Plymouth South High School
Plymouth, MA
Ai3 Project # - 1308.00

Addendum #1

June 5, 2015

SANITARY LIFT STATION DETAIL

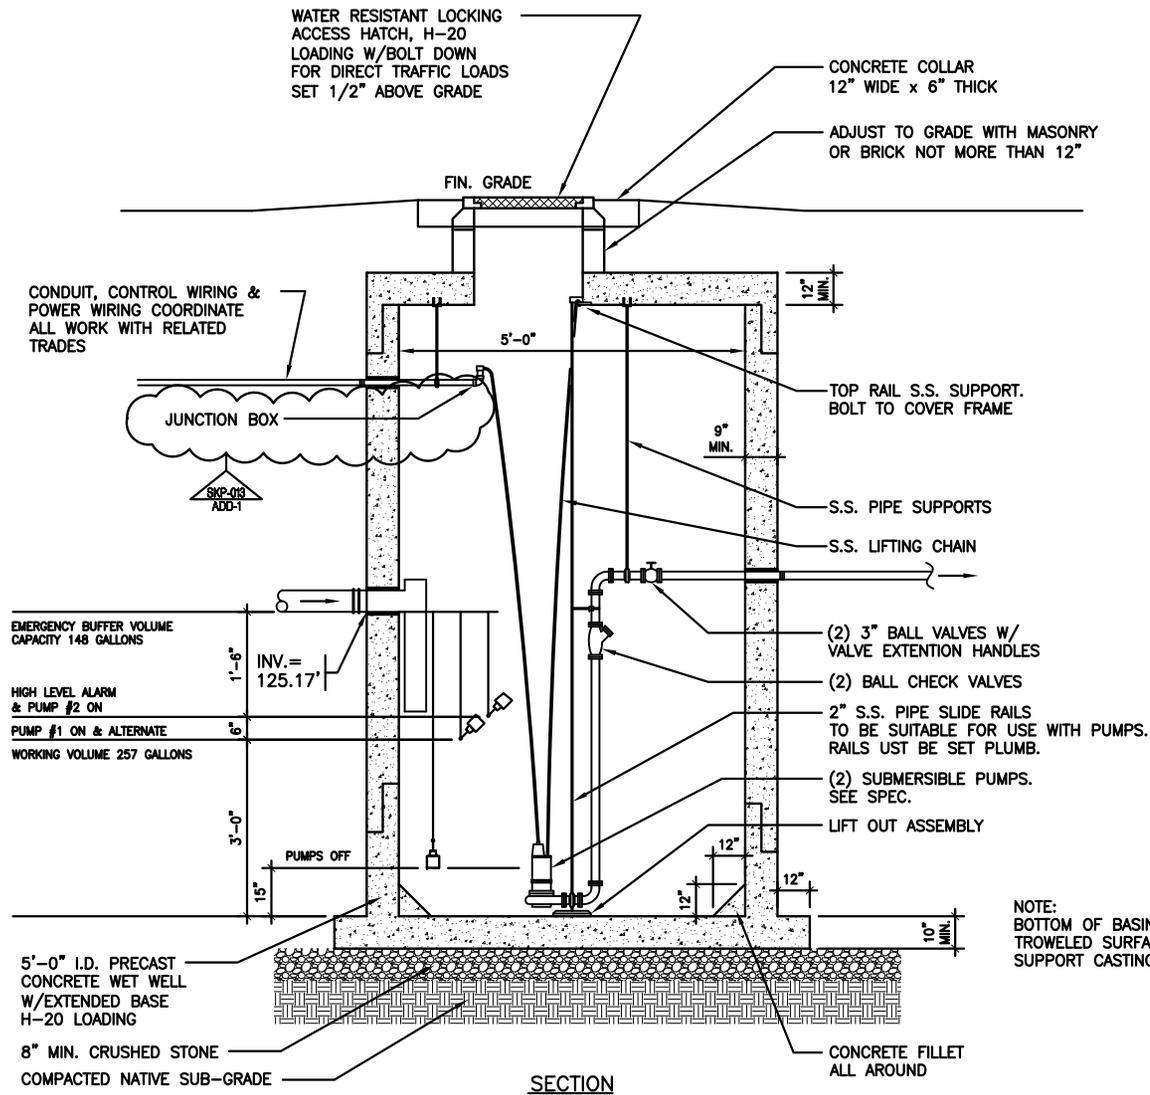
- ADD 1-0150 Drawing P2.3 Culinary/Kitchen Water & Gas Piping Plans
Sanitary Lift Station Detail, REMOVE explosion proof from junction box note.
- ADD 1-0151 Drawing P2.4 Science Class Rooms Plans & Details
Science Classroom, ADD plumbing notes.
Science Classroom, ADD plumbing notes.
Science Classroom, ADD plumbing notes.
Science Prep Room 1, ADD plumbing notes.
Part Plan, Chemical Storage Room Vac., Gas. & Water Piping Partial Plan "A", ADD piping and plumbing notes.

SKE-001

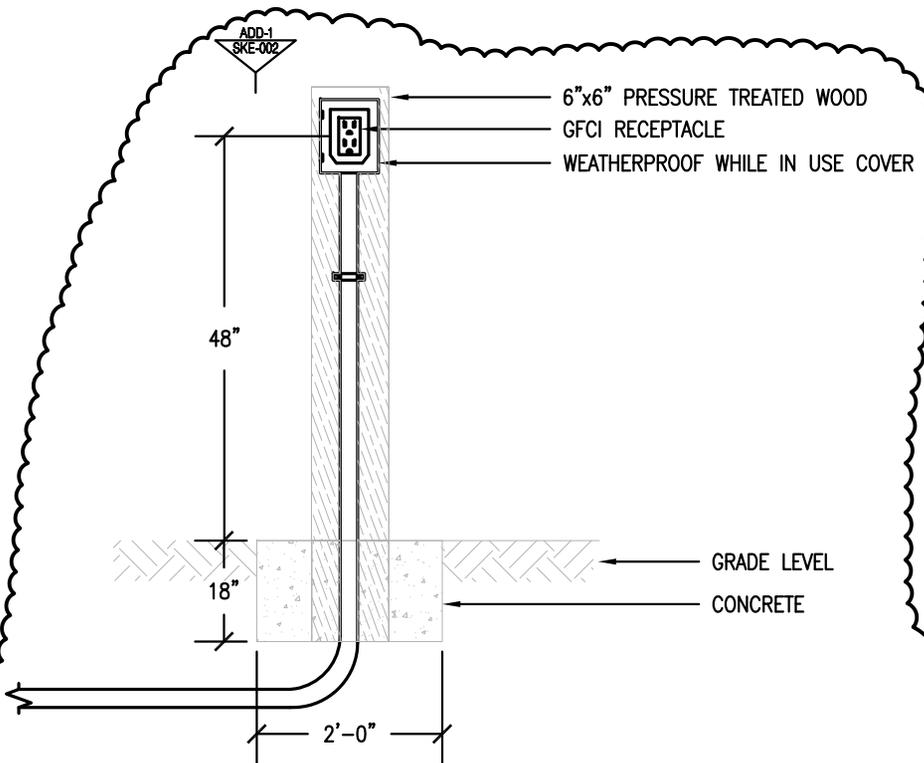
- ADD 1-0154 Drawing ES.1 Site Electrical Renovation Plan
Add receptacle at finish line.
Revise Key Note 1.
- ADD 1-0155 Drawing ES.4 Site Plan Details Electrical Continued
Revise Primary Electric Service Conduit to 4".
Revise Ductbank A-A.
Revise Ductbank D-D.
Delete 5" Spare Conduit.
Add Pressure Treated Wood Mounted Receptacle Detail.

SKE-006
REF DWG: E1.13L,E1.14L,E1.15L,E1.16L

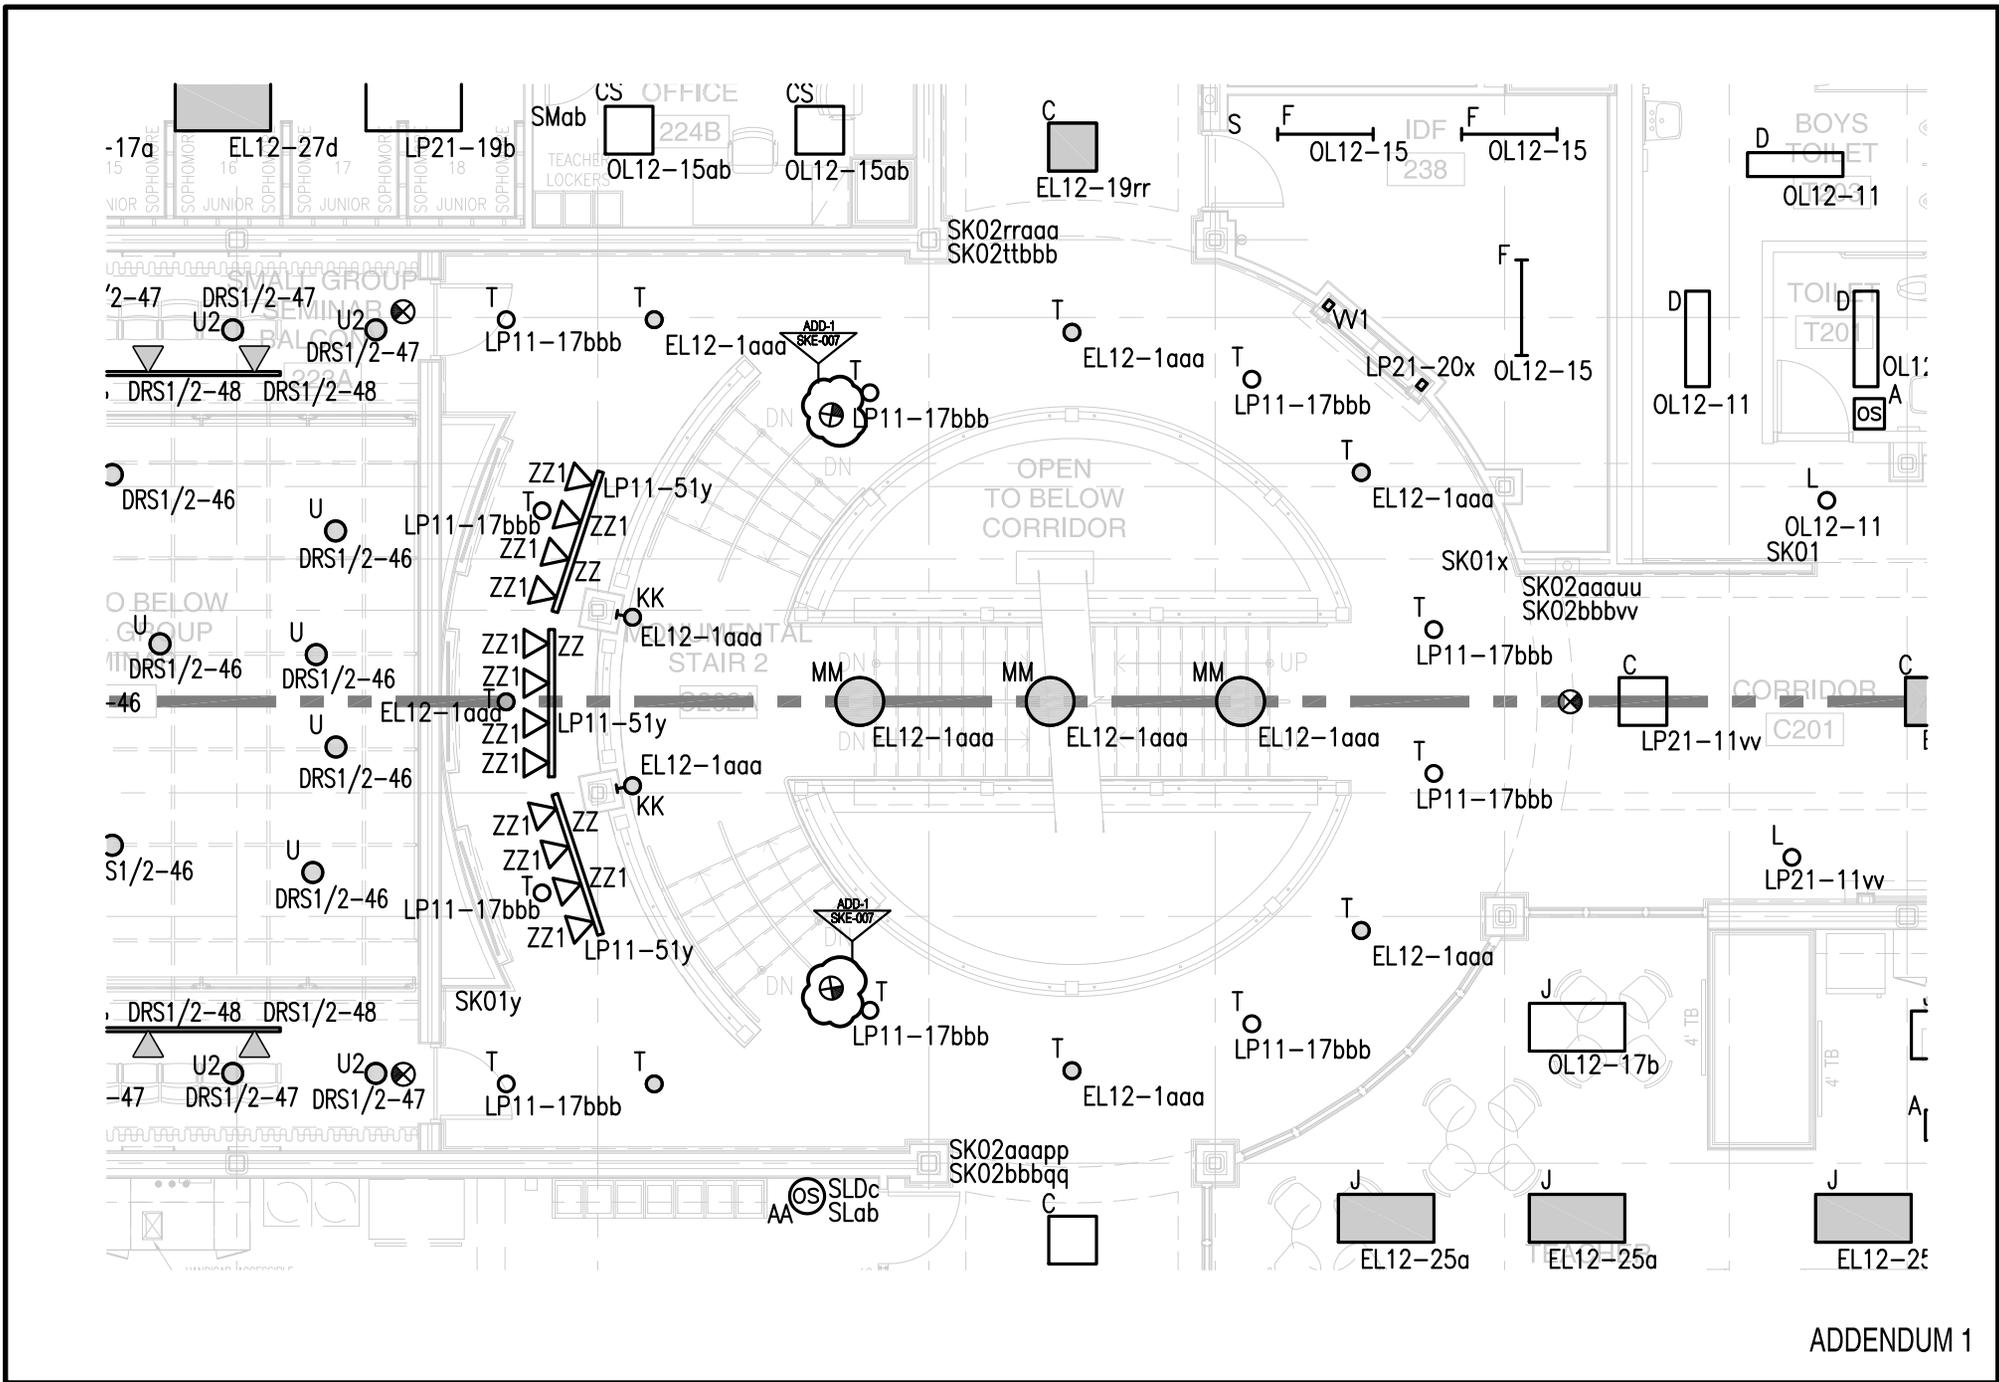
- ADD 1-0159 Drawing E1.13L, E1.14L, E1.15L, and E1.16L First Floor Lighting Plan Zone 3,4,5,6 and 7 Electrical
Revise lighting.
Revise occupancy sensors.
Revise switching.
Revise circuiting.

SCHOOL FIRE ALARM RISER DIAGRAM

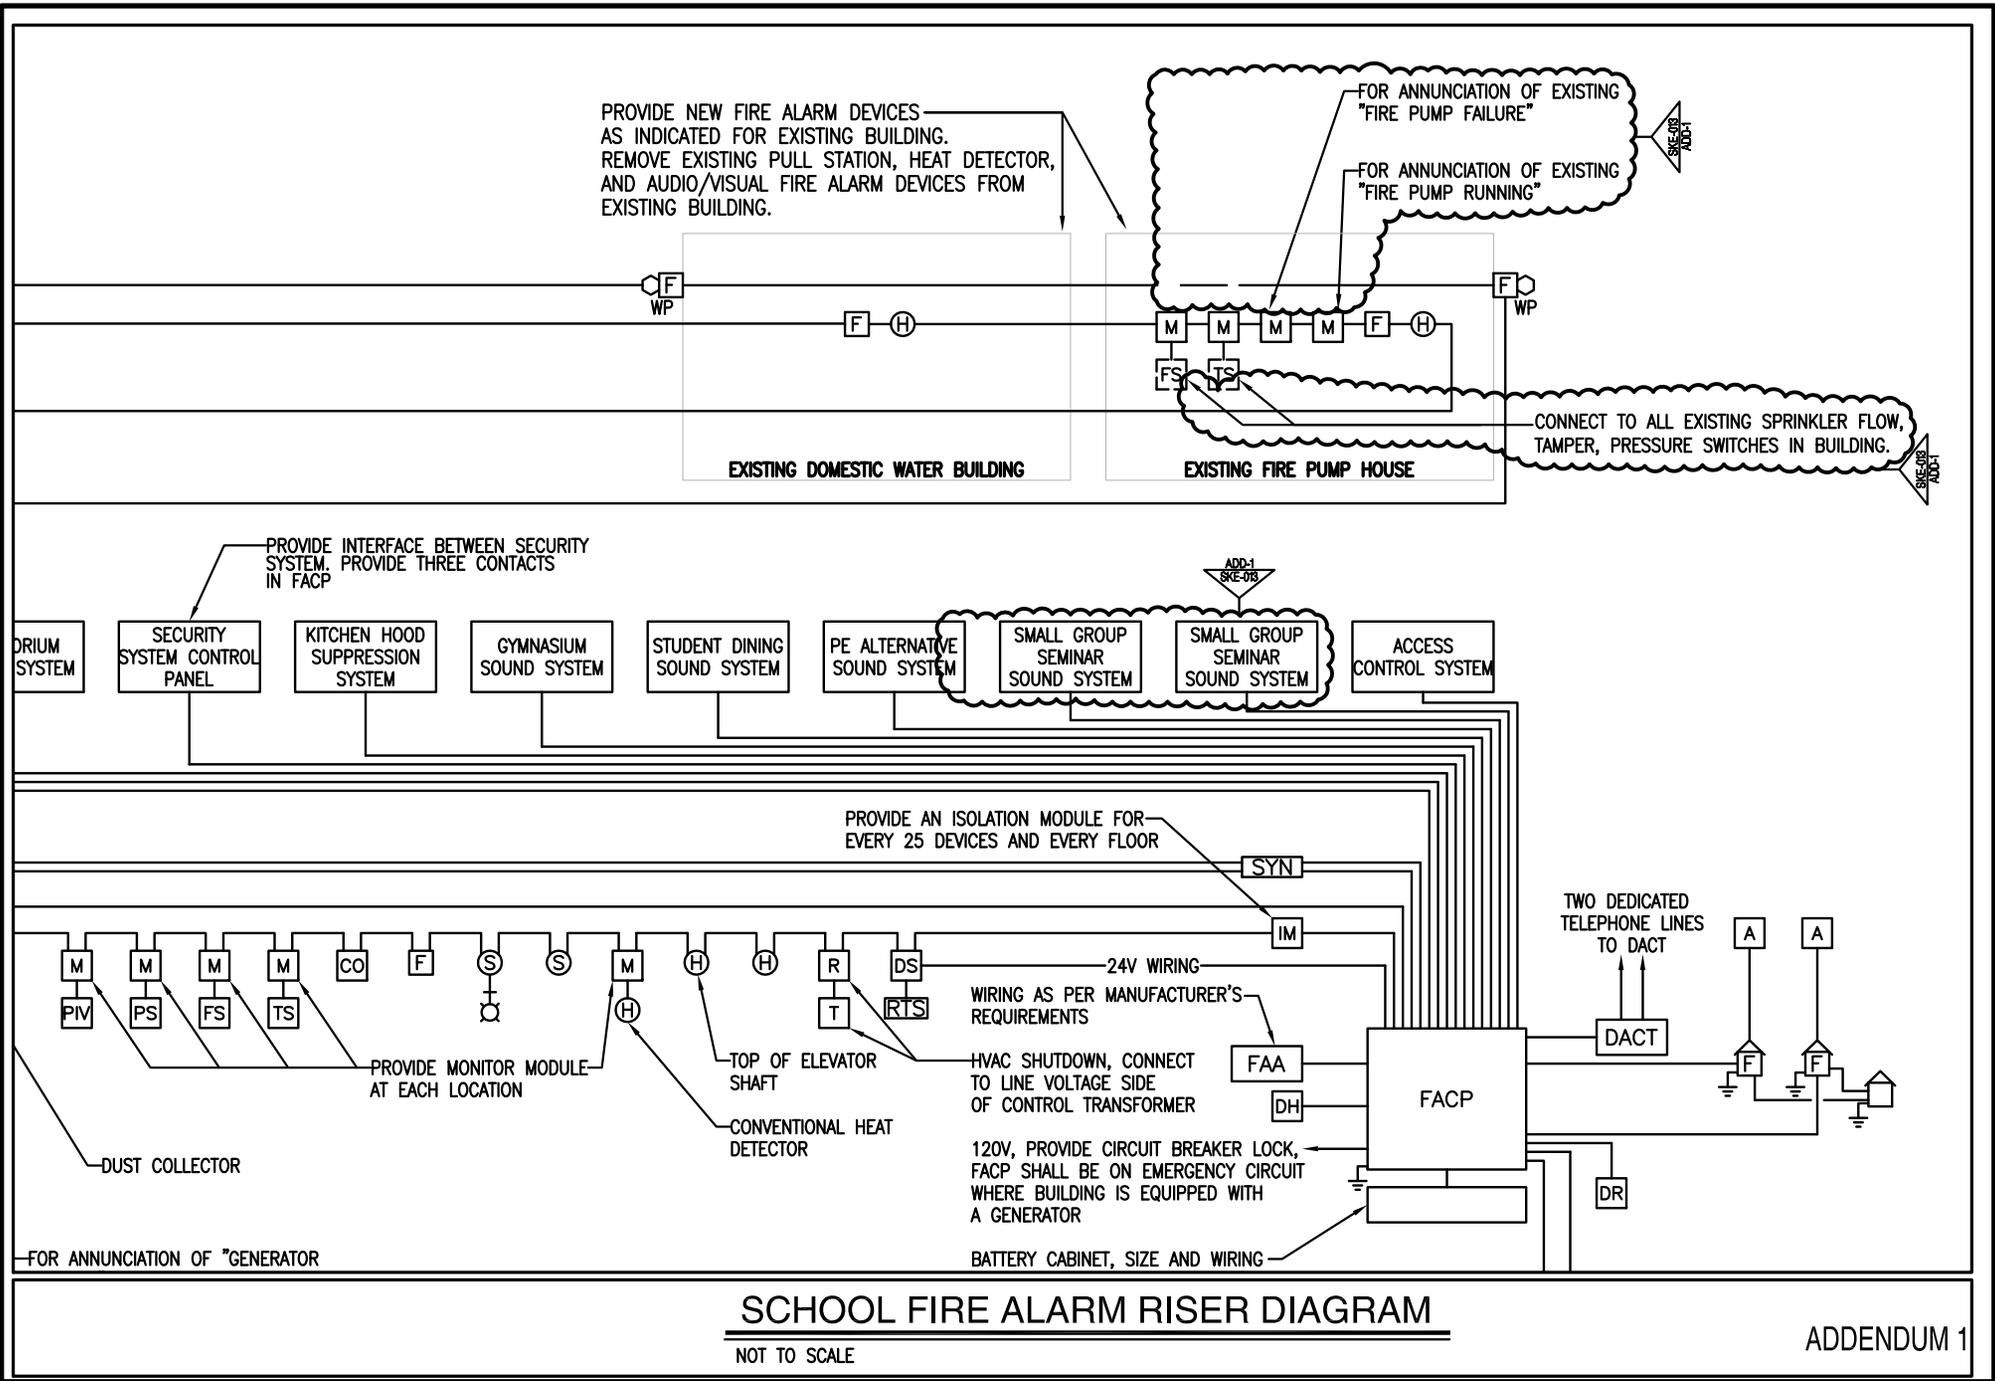
- ADD 1-0165 Drawing E1.32P Third Floor Power Plan Zone 2 Electrical
Add receptacle on roof near elevator louver.
- ADD 1-0166 Drawing E2.5 Fire Alarm Riser Diagrams
Revise School Fire Alarm Riser Diagram.

SKM-001
REF DWG: M1.13

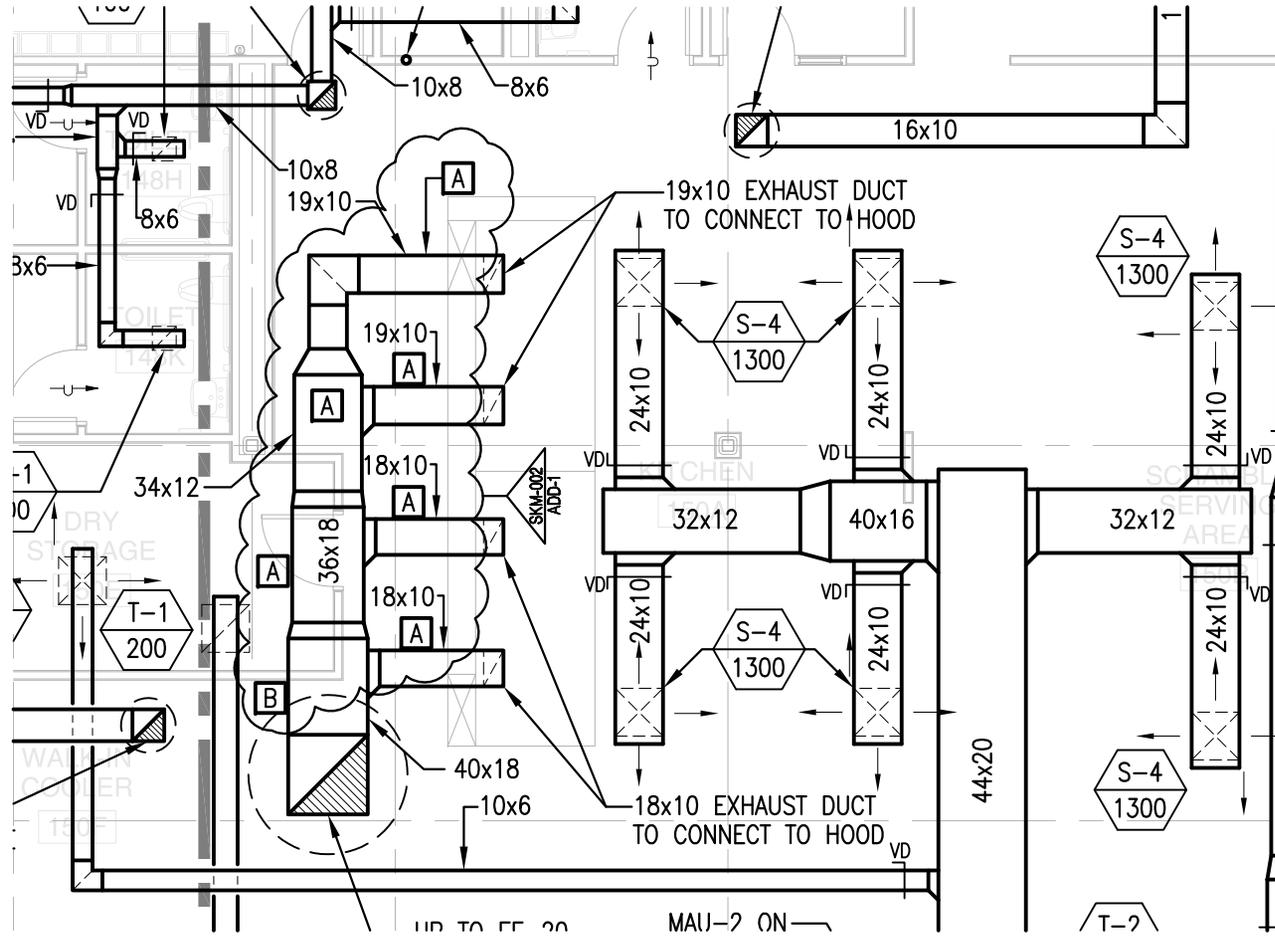
- ADD 1-0152 Drawing M1.13 First Floor Ductwork Plan Zone 3 Mechanical
Add access panels for ductwork clean-out.
- ADD 1-0153 Drawing M1.14 First Floor Ductwork Plan Zone 4 Mechanical
Add access panels for ductwork clean-out.

A 8"x8" ACCESS PANEL AT SIDE OF DUCT W/
 FIRE RATED GASKET FOR DUCT CLEAN-OUT
B 12"x12" ACCESS PANEL AT SIDE OF DUCT W/
 FIRE RATED GASKET FOR DUCT CLEAN-OUT
